A66 Northern Trans-Pennine project

Proposed changes consultation

January/February 2023

DC-17 – Café Sixty Six – Revised land plan

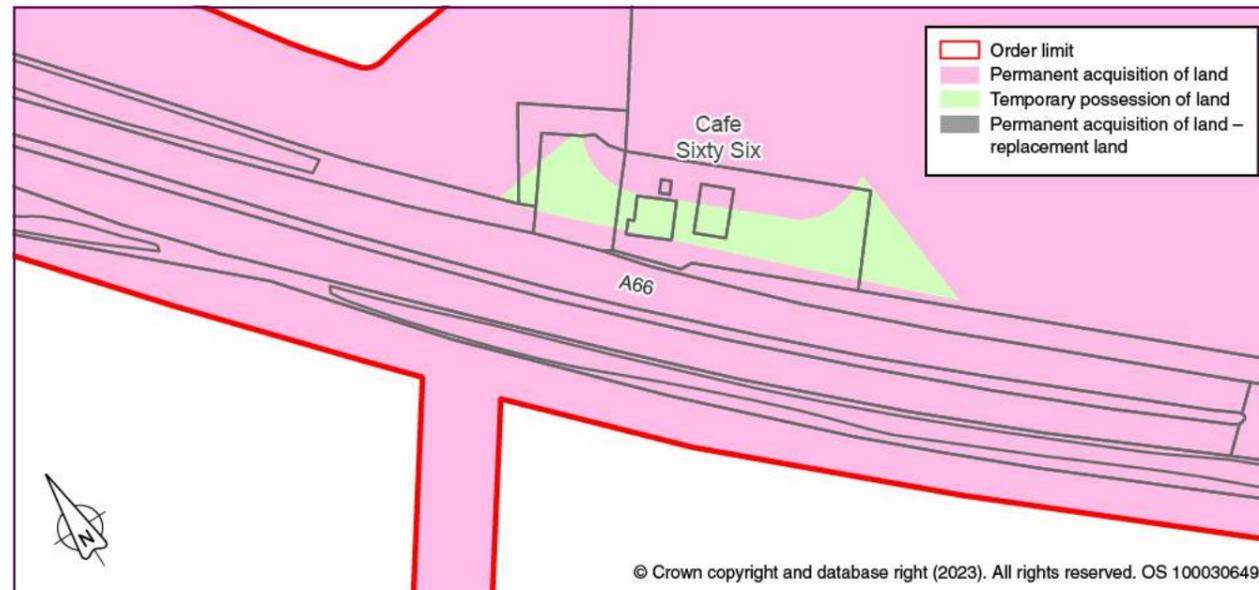
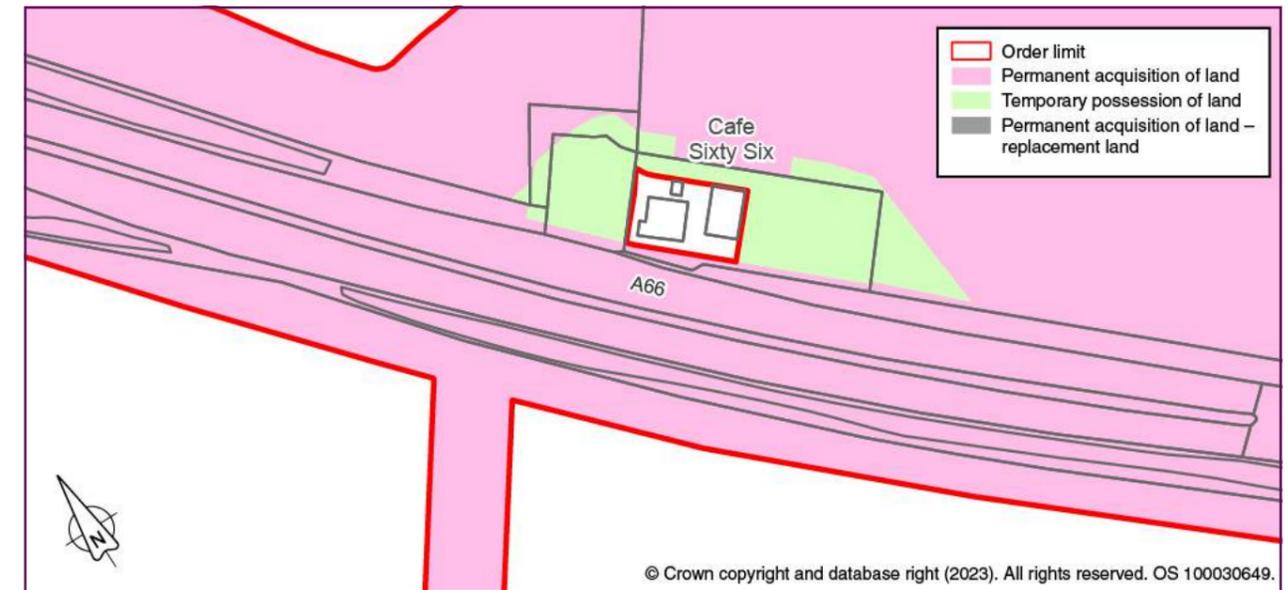
café area. Inadvertently, our plans show this loop road impacting on the café buildings.

We will correct this on our DCO plans and we are looking at opportunities in detailed design to simplify this access arrangement with input from the landowner.

This change will amend the land plans and reduce the amount of land we need to acquire from the landowner or occupy on a temporary basis.

DCO design alongside proposed change

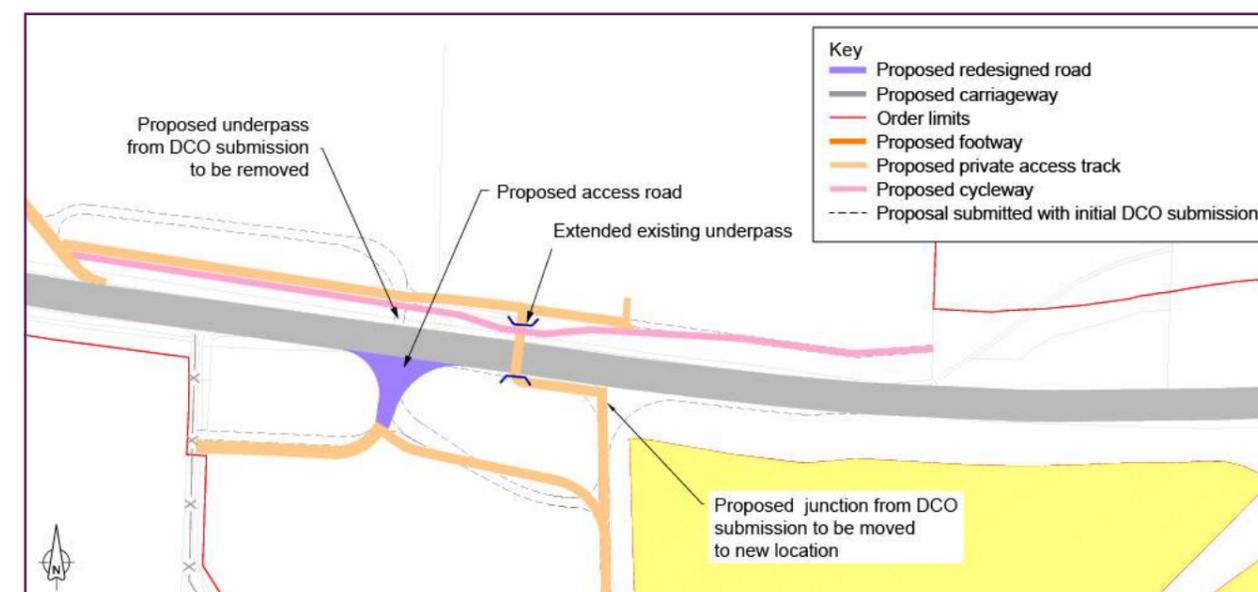
Our proposed change would see the retention of the existing underpass and its extension under the new walking and cycling route to the north of the A66 instead of creating a new underpass. This underpass connects land to the north and south of the A66.

We plan to move the proposed new westbound left-in, left-out access approximately 150m to the west which would provide access to New Hall Farm and Far Bank End. This would be a shared route for both farms and their businesses. This change would enable the underpass to continue to be used exclusively by the landowner to avoid potential conflict between cattle and walkers and cyclists.

By not providing a new underpass, this would reduce earthworks, materials and associated construction traffic on the local network. It would also reduce construction time and disruption to road users.

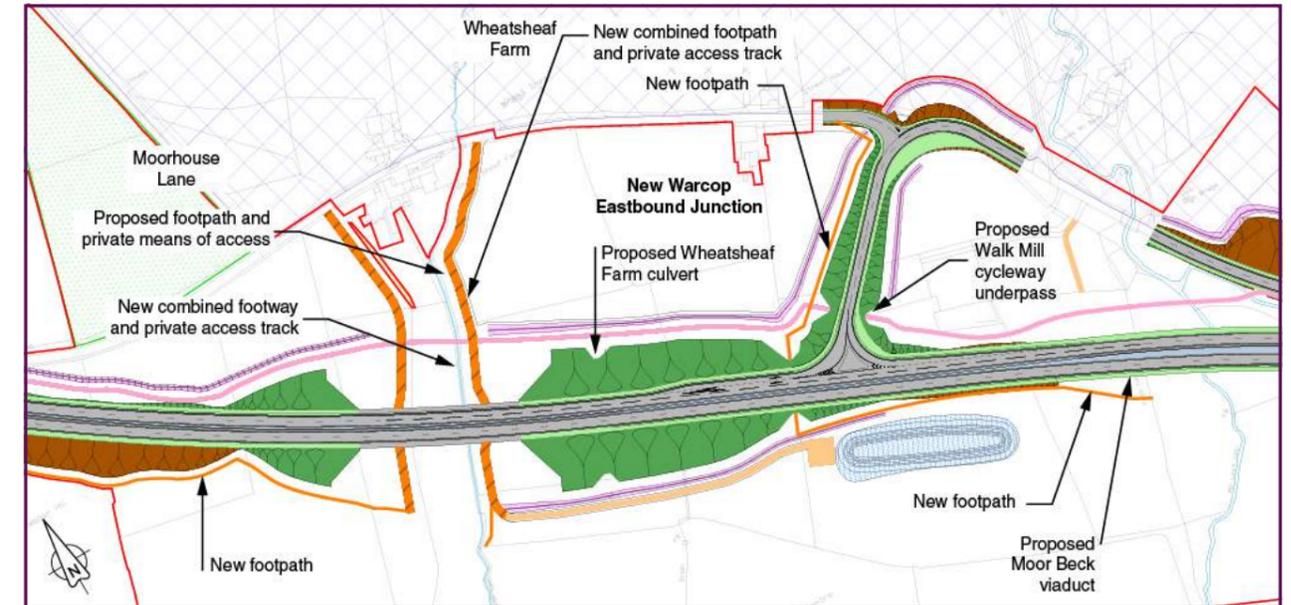
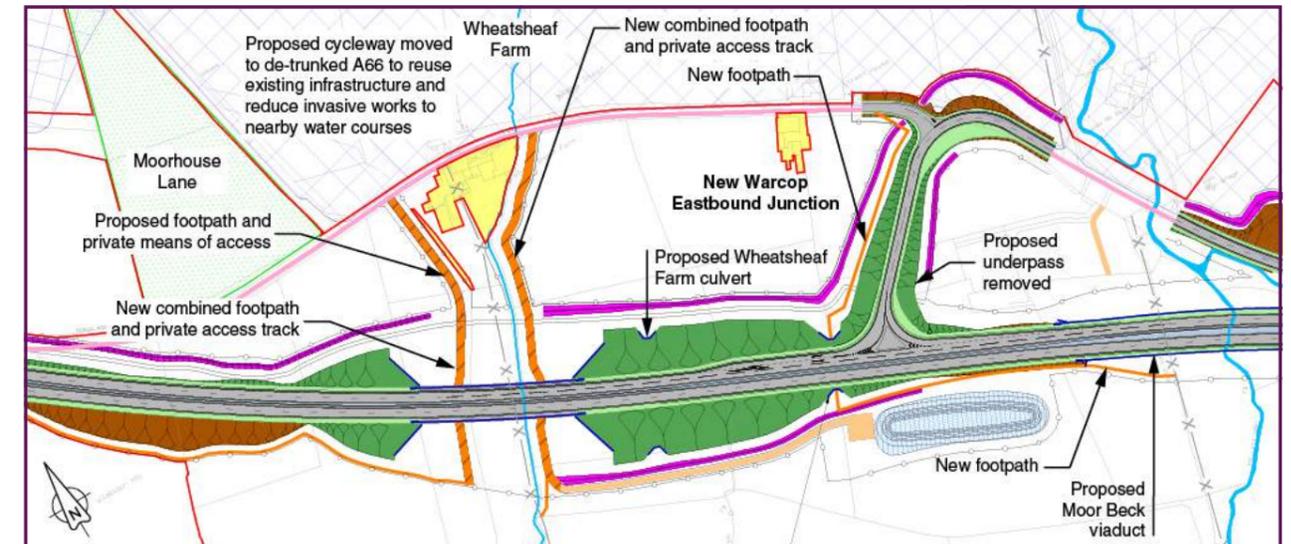
We are planning on re-routing a small section of the walking and cycling route to move it away from the new A66 and out of the floodplains of Moor Beck and Cringle Beck. The proposed route will utilise part of the old, de-trunked A66 road instead (see plan below).

This change will move walkers and cyclists away from the new alignment and onto the de-trunked A66 providing a more rural setting. The speed limit on the local road is proposed to be reduced to 30mph to make the route safer.

The change allows us to repurpose the old A66 as a footpath and cycleway, removing the need for construction of a new route. It will also remove the need for an underpass from the side road, meaning walkers and cyclists would no longer be required to pass underneath the road. If required, this underpass would have needed lighting which would not be appropriate in this rural location.

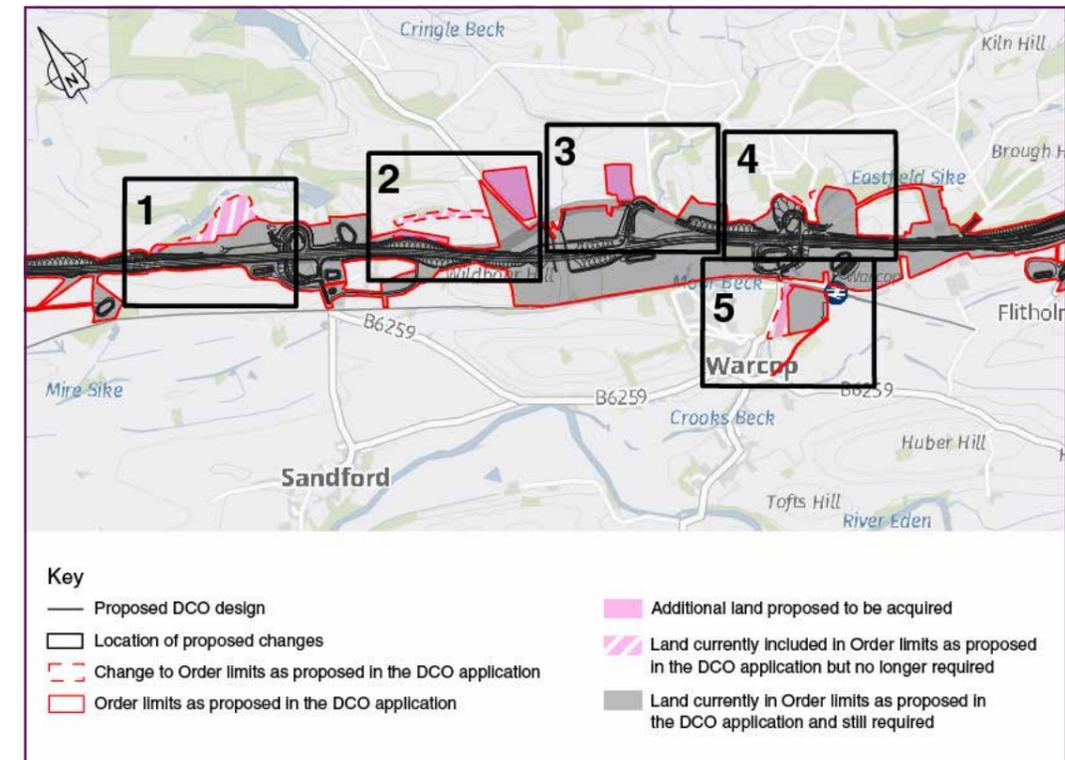
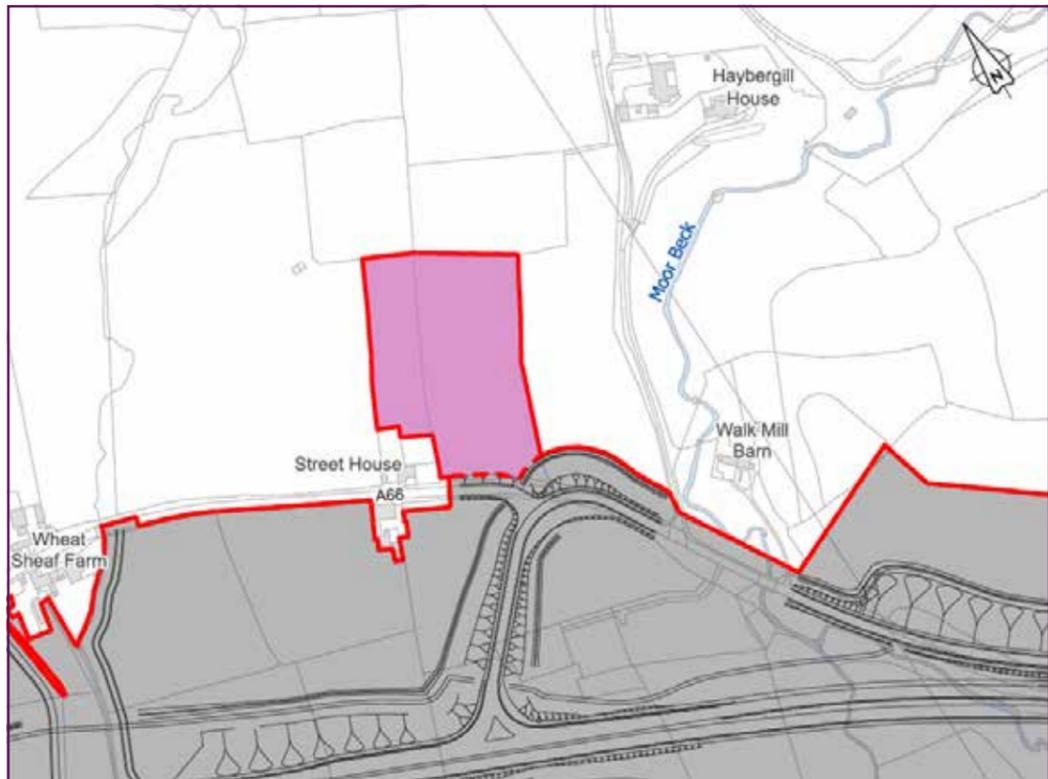
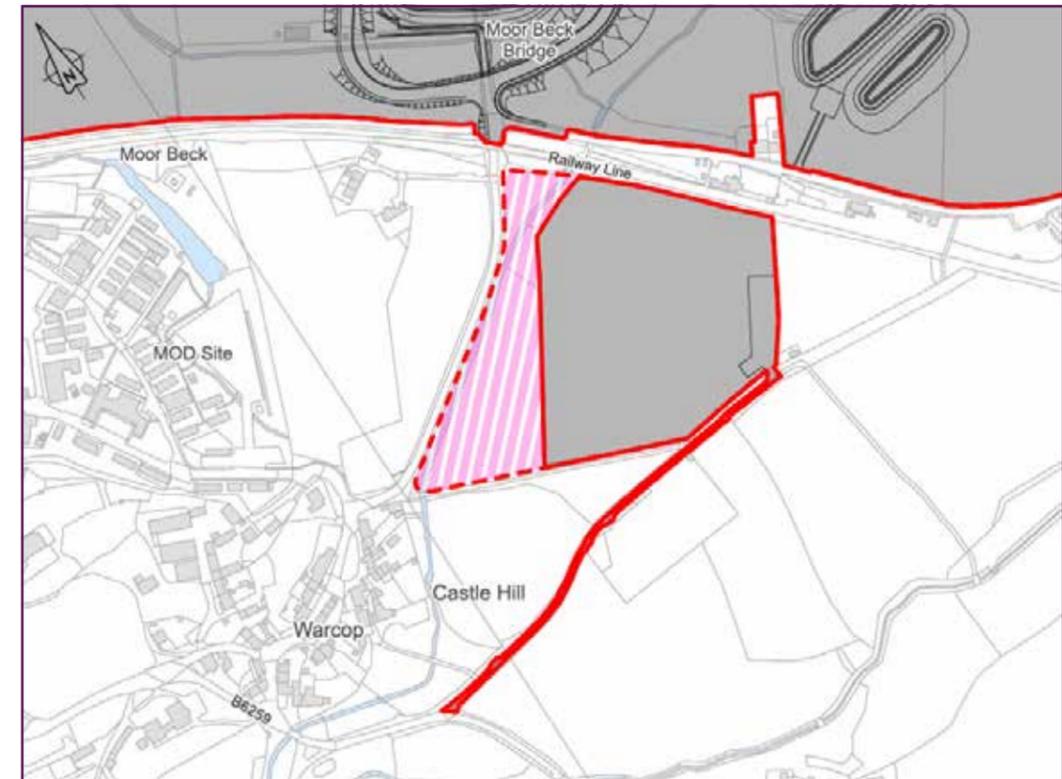
In our ongoing discussions with the MoD, they have told us that some of the land we have proposed to use for mitigation for the scheme is now required for their operational purposes, including the training of troops, which is fundamental to the functioning of the site. They have explained that areas north of the A66 are tactical land and particular locations are of strategic importance.

The MoD have suggested some alternative locations outside of the Order Limits where mitigation planting will not impact on the operations of their site. The changes are shown in the plans. This would require a change to the Order Limits for our DCO application.

Amendments to the Order Limits within Ministry of Defence land. Increase in the land required to accommodate design changes to ensure the operational requirements of the site are not compromised.

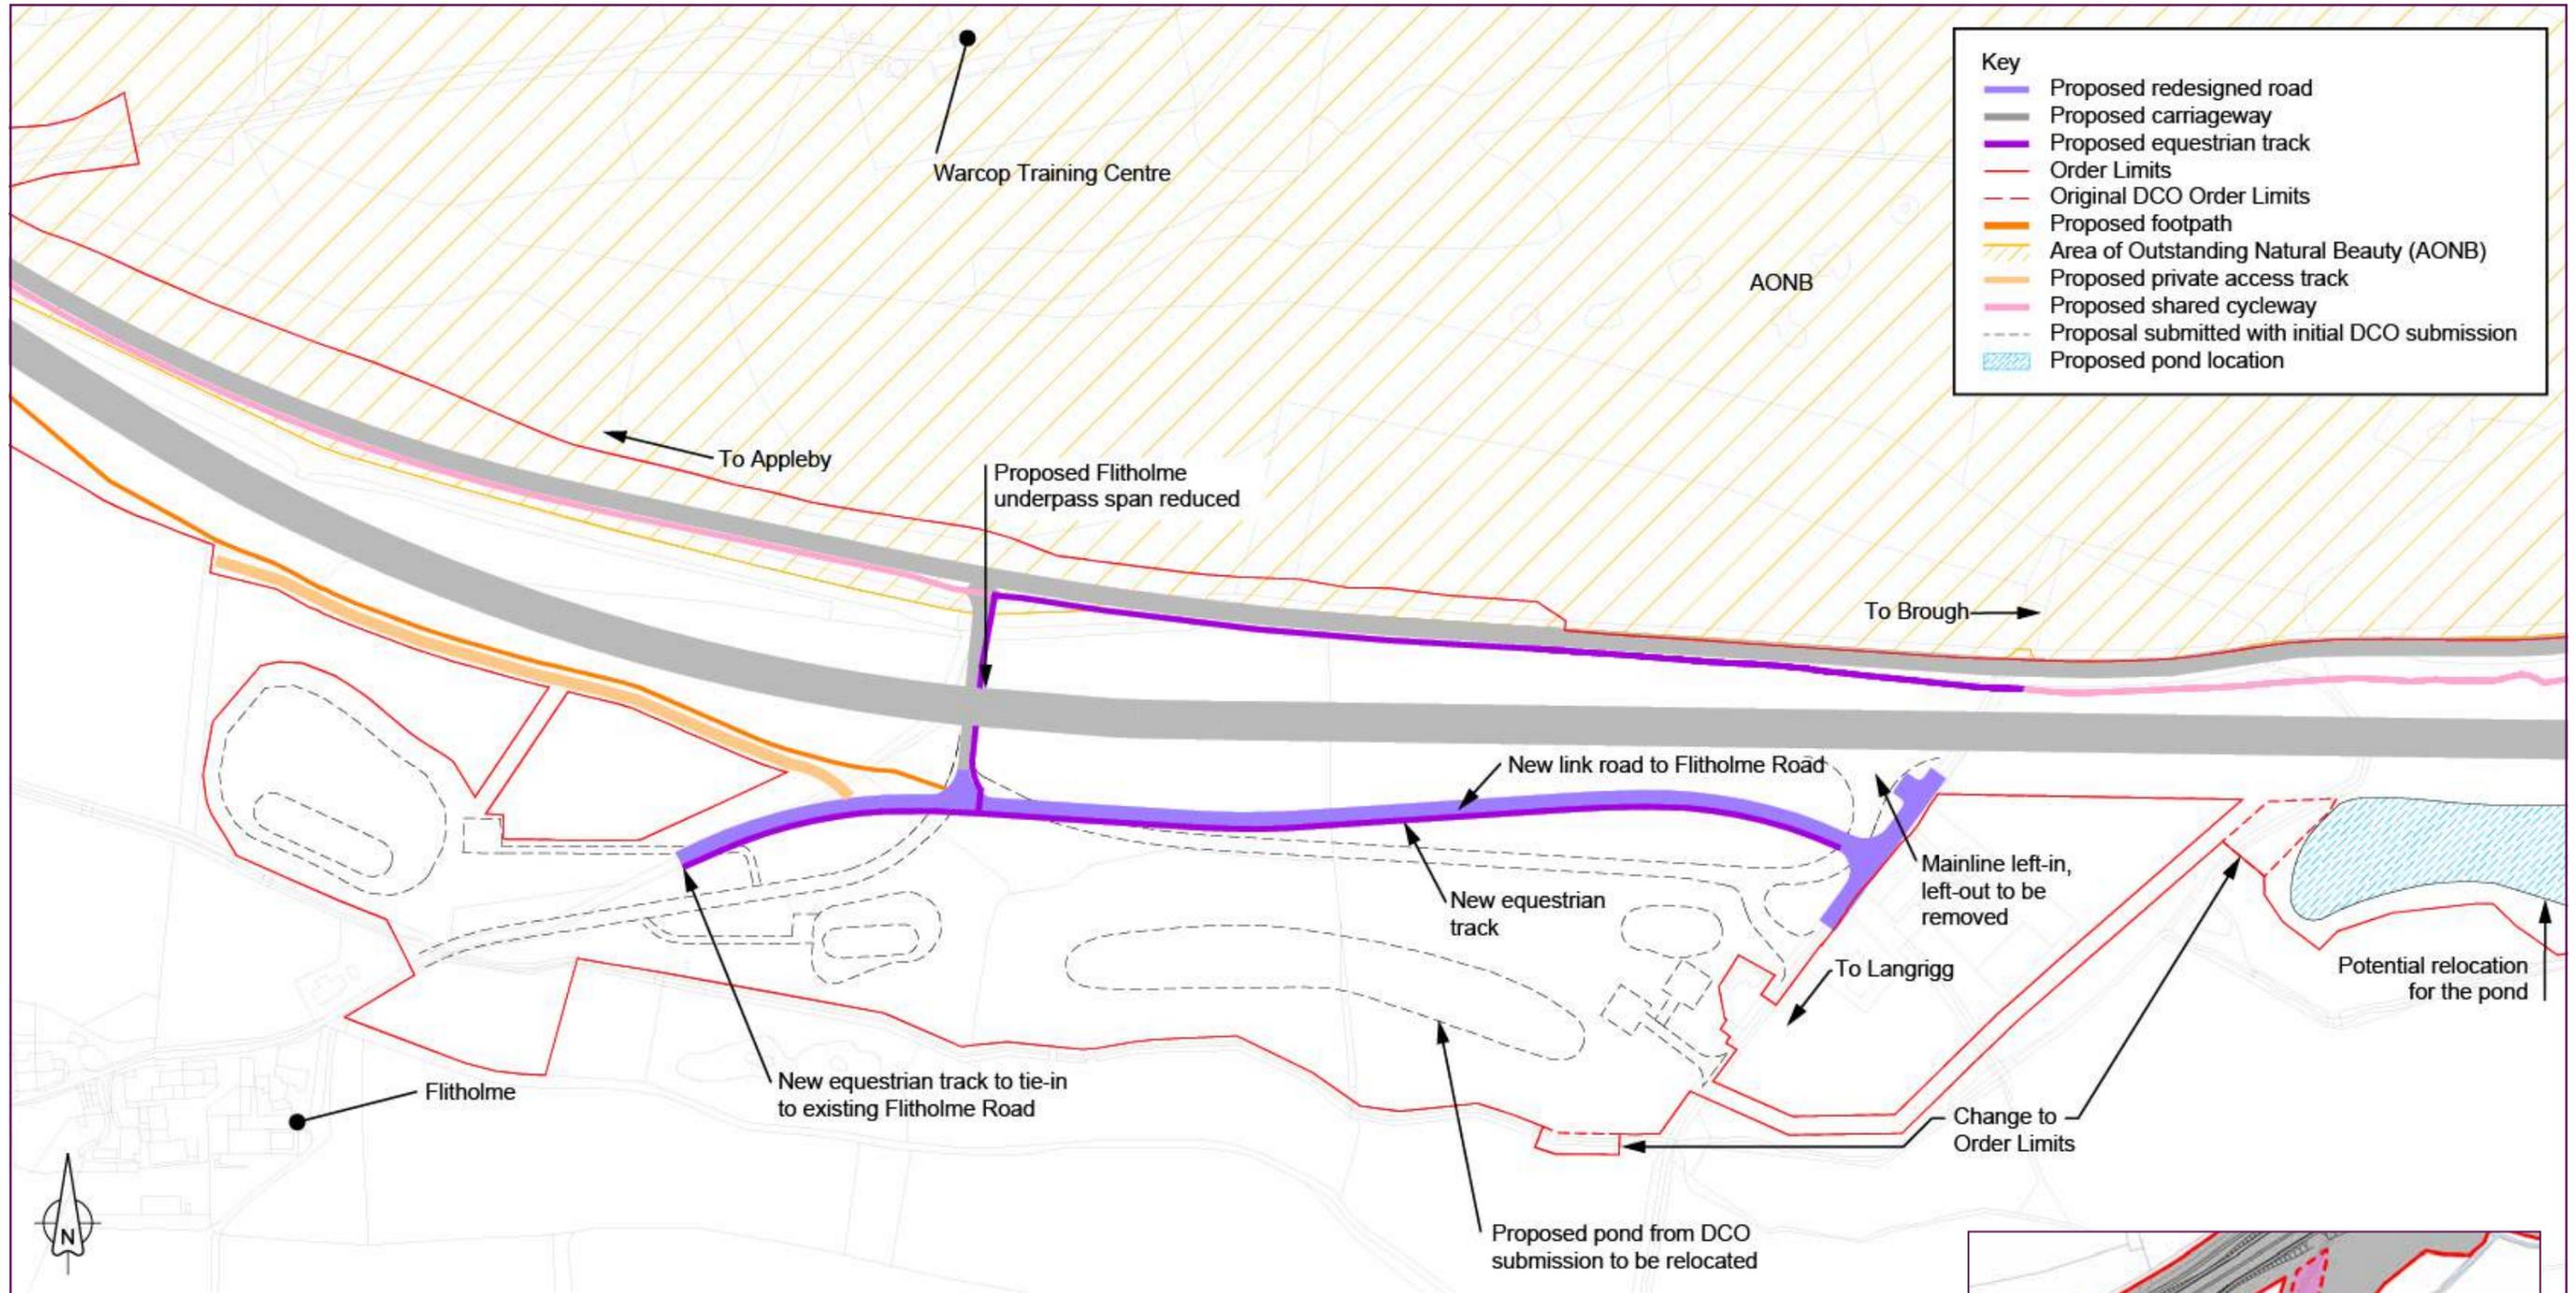
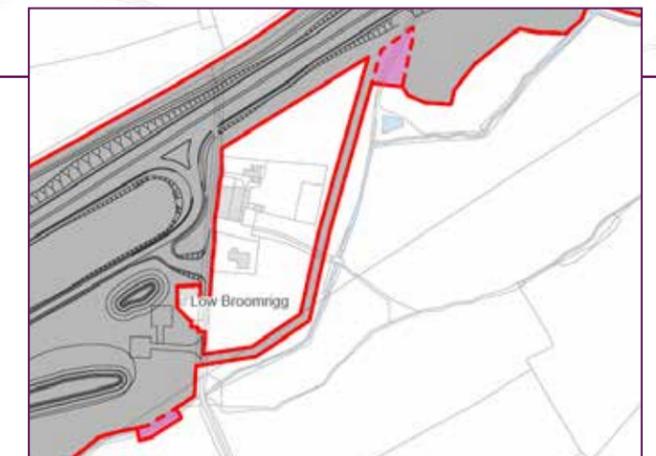
By tying in the Flitholme Road junction 100m to the north of the bridge over Lowgill Beck, we can also reduce impacts on residents in that area.

The removal of the Langrigg junction allows the link road and associated infrastructure to move north. The relocation of the largest balancing pond away from an area of fen, which is considered a priority habitat, provides the opportunity to reduce environmental

This plan helps to compare the DCO design with the proposed change at Langrigg. The DCO design is shown in dotted black with the proposed change (in principle) shown in colour. Further detailed design of aspects such as ponds and accesses continue to be developed.
